ADDENDUM NUMBER TWO
RFQ # 7549063

TITLE: Benefit Street Arsenal-Building Envelope and Fire Alarm Repairs

RI Army National Guard Benefit Street Arsenal
176 Benefit Street
Providence, RI 02903

ADDENDUM NUMBER 2

2 SECOND FLOOR PARTIAL PLAN
SCALE: 1/4"=1'-0"

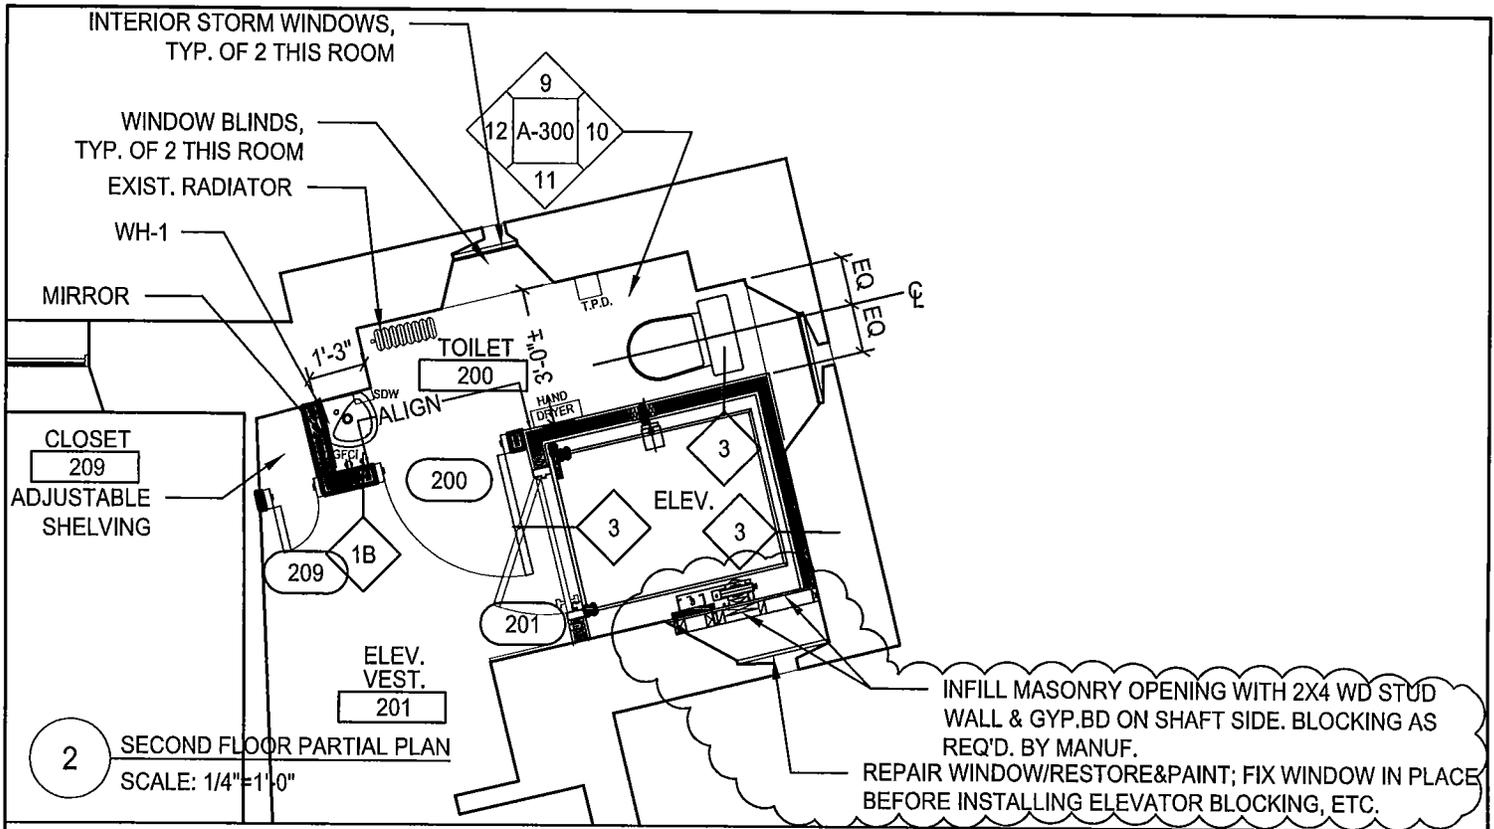
5. Drawing A-200: Change note that reads, "Cementitious coating on entire building, color to be selected by Architect." and revise to the following: "Cementitious coating on entire building, color & texture to be selected by Architect and samples to be approved by the RIHPHC."
6. Drawing A-110 & A-120: See Sketch SKA-01 for changes to the masonry opening infill material at the elevator shaft.

INFILL MASONRY OPENING WITH 2X4 WD STUD WALL & GYP.BD ON SHAFT SIDE. BLOCKING AS REQ'D. BY MANUF.
REPAIR WINDOW/RESTORE&PAINT; FIX WINDOW IN PLACE BEFORE INSTALLING ELEVATOR BLOCKING, ETC.

1 FIRST FLOOR PARTIAL PLAN
SCALE: 1/4"=1'-0"

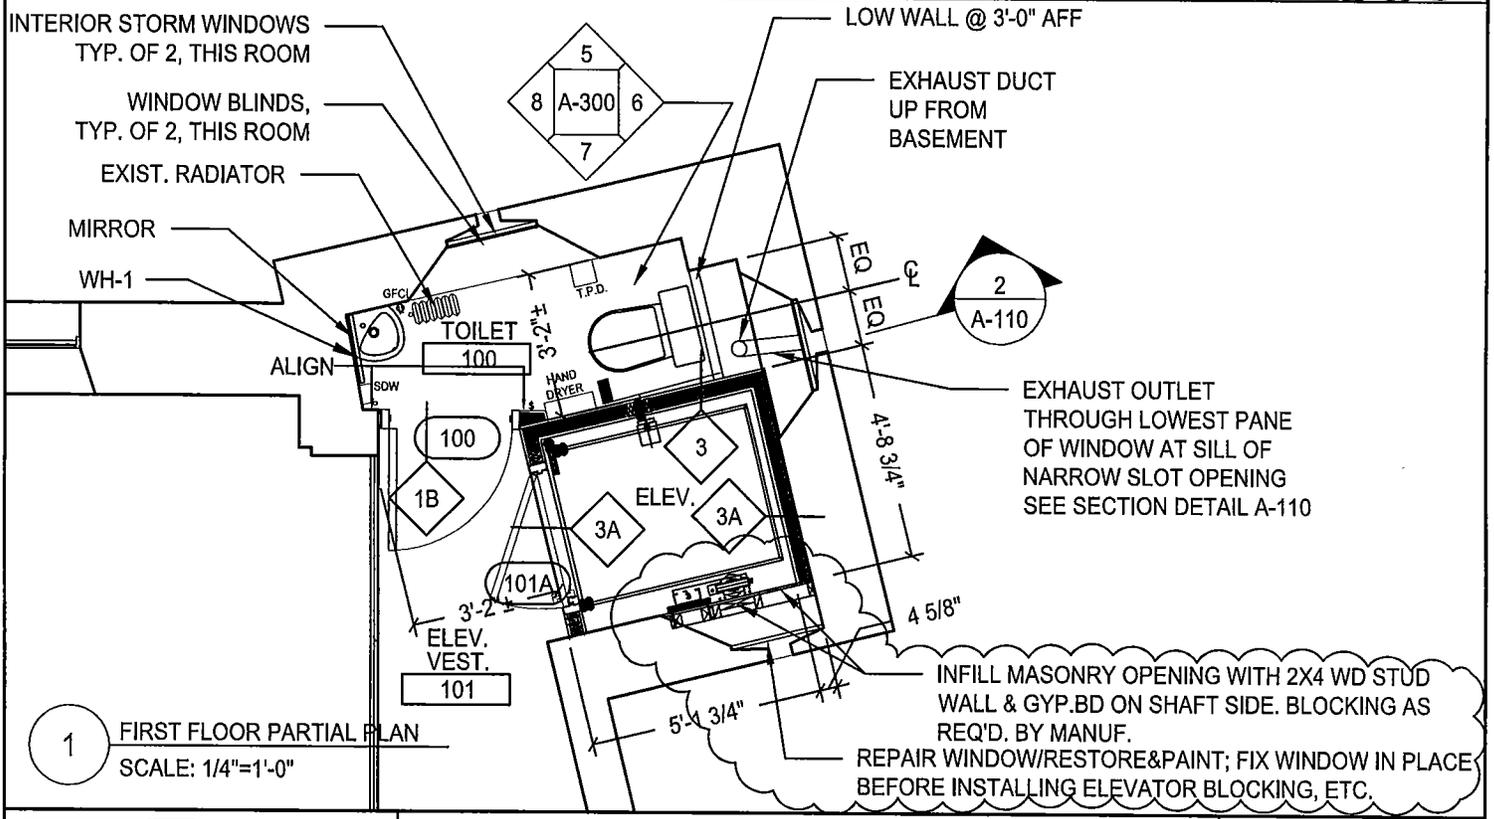
LOW WALL @ 3'-0" AFF
EXHAUST DUCT UP FROM BASEMENT
EXHAUST OUTLET THROUGH LOWEST PANE OF WINDOW AT SILL OF NARROW SLOT OPENING SEE SECTION DETAIL A-110
INFILL MASONRY OPENING WITH 2X4 WD STUD WALL & GYP.BD ON SHAFT SIDE. BLOCKING AS REQ'D. BY MANUF.
REPAIR WINDOW/RESTORE&PAINT; FIX WINDOW IN PLACE BEFORE INSTALLING ELEVATOR BLOCKING, ETC.
